# Appendix 8.1 Noise Consultation

**Subject:** Energy Isles wind farm - supplementary consultation re: noise

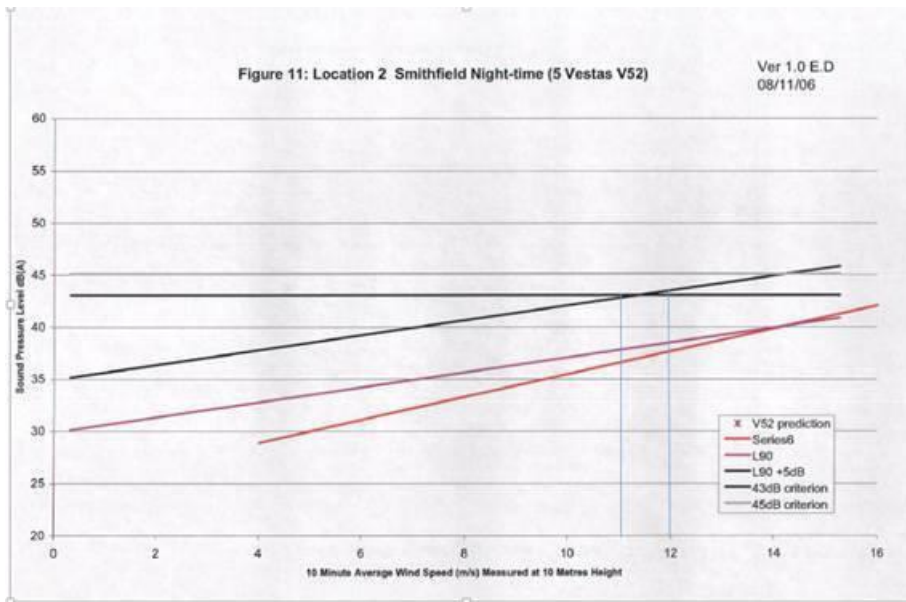
\* The noise limits for Garth wind farm are not tabulated in the Garth EIA. We note that the fixed minimum ETSU limits were set at 40 dB daytime / 43 dB night-time, and have sought to interpolate the limits from the graphs provided in the Garth EIA appendix (attached) for Smithfield (monitoring location 2). Our interpretation of the graph and the tabulated limits we have used are shown below:

Daytime period:

Wind speed, m/s	4	5	6	7	8	9	10	11	12	13	14
Limit, dBLA90,10min	40.0	40.0	40.0	40.0	40.0	40.8	41.7	42.5	43.3	44.2	45.0

Note – 13 & 14m/s provided to show derivation of assumed limits. Noise limits will apply across range 4m/s – 12m/s in accordance with ETSU.

My apologies for the delay in responding to your last email. I have discussed your proposed method for determining the developments noise limits with my colleague and have confirmed that the information submitted is acceptable and in compliance with the guidelines as detailed in R97-GPG.
